Response to Tims landscape comments dated 12th March 2026:

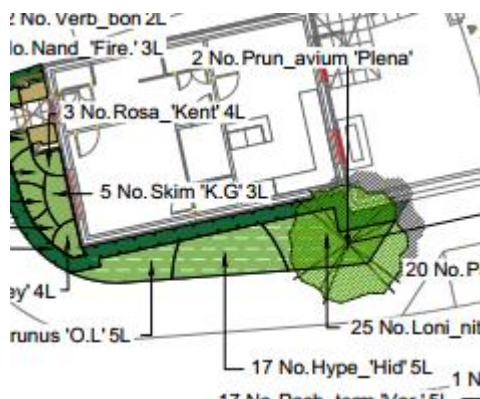
e/ 2 no. *Corylus avellana* - native but likely to swamp space. Replace with alternative species such as *Viburnum opulus* 'Roseum' or purple variety of *Corylus*. **Noted will be updated**

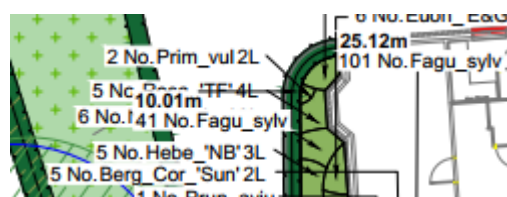
m/ Some labelling 'over-writtten' as below: **Noted will be updated**

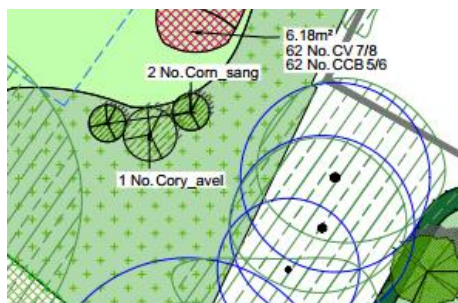
q/ Increase numbers of these plants. Group of 3 Corylus and 5 Cornus min. At present too few for decent effect in such a wide-open space. Relocate group toward a boundary as currently 'floating' within swathe of wildflower grass? **Noted will be updated**

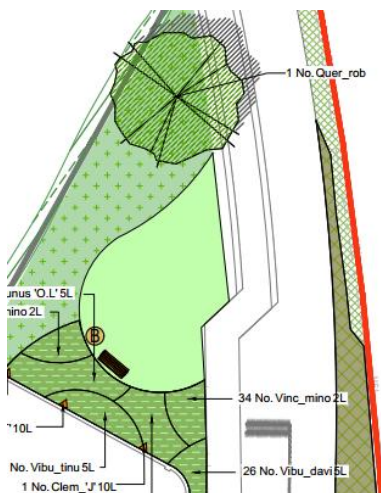
r/ Perhaps this is a location for a true focal tree to mark arrivals onto the site?:

Although generally we favour natives, this might be a location for a specimen such as a Tulip tree or Sweet Gum or similar foliage/flowering species. **Approved under RM no change.**

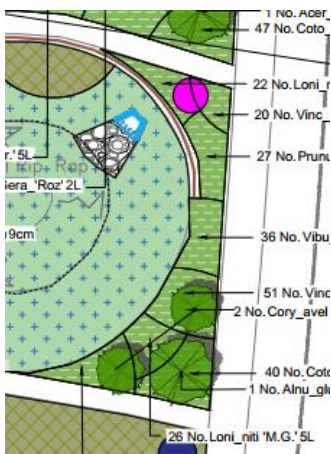
t/ What do the blue and magenta symbols represent?

Blue = Waymarker locations

Magenta = Information board locations

These will be added to the key.

Proposed surface finishes dwg. **Approved under Outline condition discharge no change.**

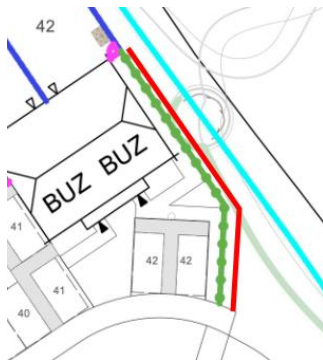
Key - amend note for Golpa to read Buff gravel not buff grid.

Visitors parallel parking bays along more informal w edge (6 spaces) - replace blocks with Golpa for softer effect.
